PRESSURE RELIEF VALVES WITH YCR/VCB APPLICATIONS

Supersedes: Nothing 192 Form 195.21–EG2 (Supl. 1)

SUBJECT: RELIEF VALVE &YCR HIGH PRESSURE CUTOUT SETTINGS

TYPICAL PIPING ARRANGEMENT—VCB WITH INDOOR CHILLER

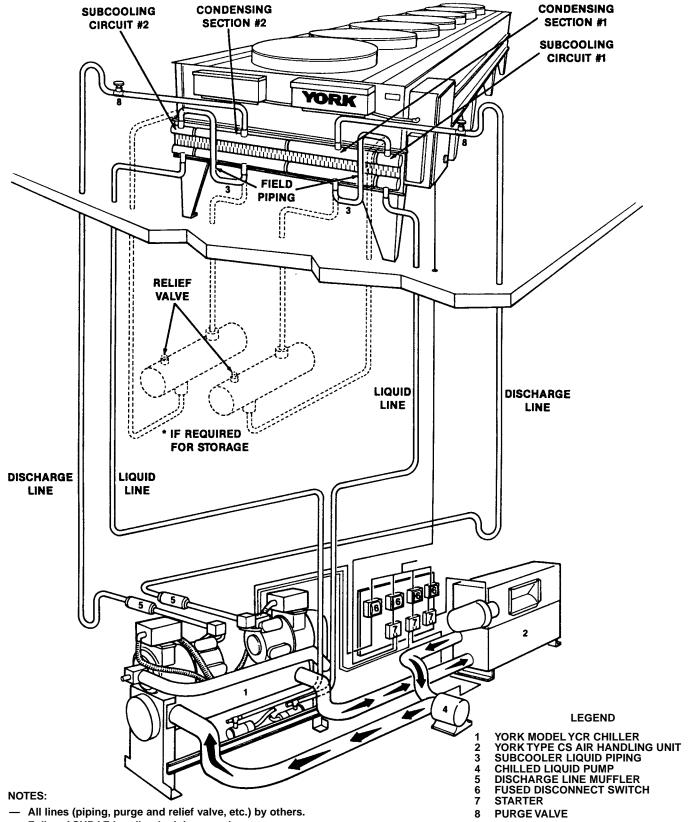
The diagram on the reverse side supersedes the illustration shown on page 10 of Engineering Form 195.21-EG2 (191).

- Follow ASHRAE handbook piping practices.
- *Receivers are normally not used. If they are required for service storage, they should be installed just under the roof line and 12 to 15 feet above the chiller refrigerant liquid connections.
